PRODUCT BULLETIN

Title: New Style Coupling & Hose Obsolescence
Product Line: Bolting Systems
Document #: PMB1903
Date: April 2, 2019

Product Affected: Bolting System Tension Hoses: HL1M-LC, HL13M-LC, HL3M-LC, HL5M-LC, HL8M-LC, and HL10M-LC

OLD STYLE COUPLING

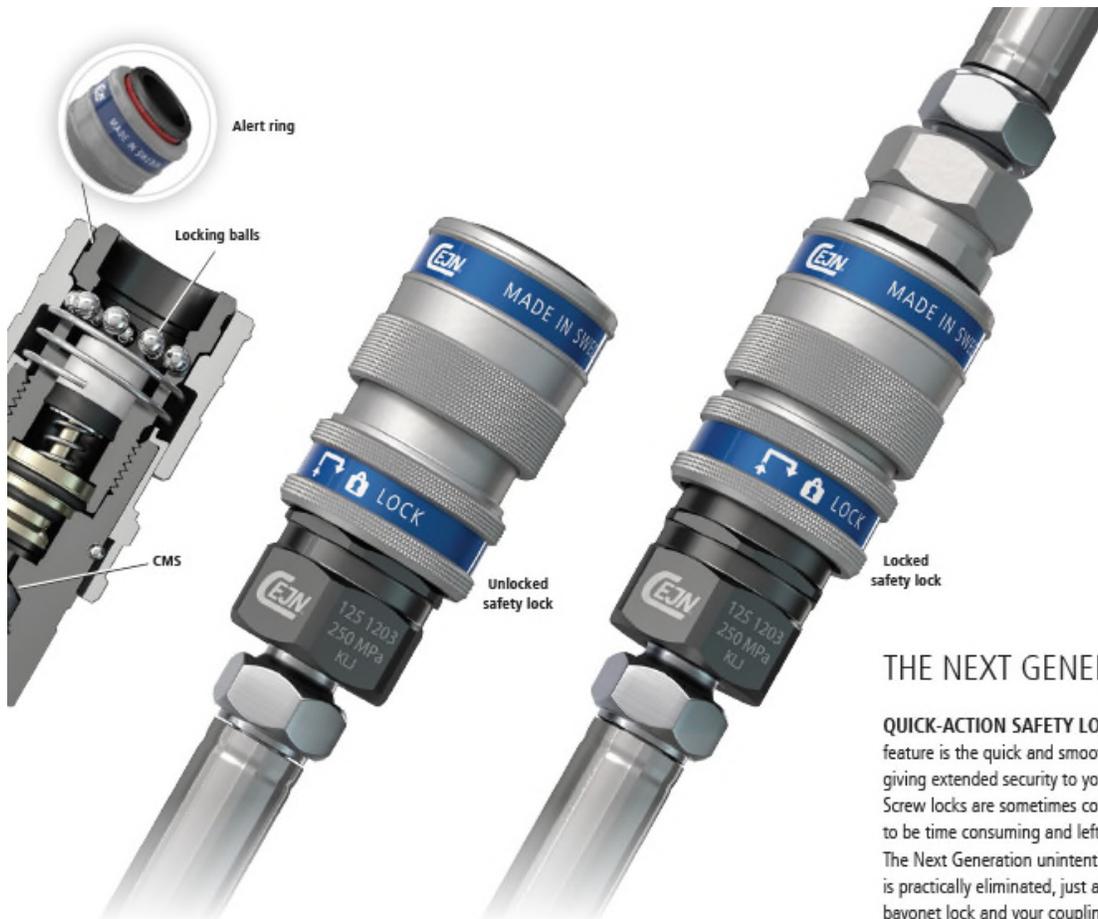
Description: Due to the discontinuation of the threaded locking collar style coupling (SPX P/No 2008547 - CEJN P/No 101161222) assembled to our 1500 bar bolt tensioning hoses, the HL**M-LC hose series will be obsoleted, and replaced by the HL**M series hose.

CEJN, the coupling manufacturer, have re-designed the standard coupling (originally the non-locking collar type) to incorporate new safety features including a new spring loaded, push and turn lock and a visual connection feature (alert indicator ring)

The new style coupling shown below, has a spring loaded, push-turn type lock which remains in an unlocked position when disconnected. Because the locking collar is maintained in the retracted position, this makes it suitable for Subsea use whereby it will not interfere with connection. The choice to engage the lock resides with the operator, but will not impact with normal function whether engaged or not. **PLEASE NOTE: the new style couplings are fully interchangeable, and compatible with existing 116 series couplers.**

SPX # 2008547
CEJN # 101161222

SPX # 2008548
CEJN # 101161202
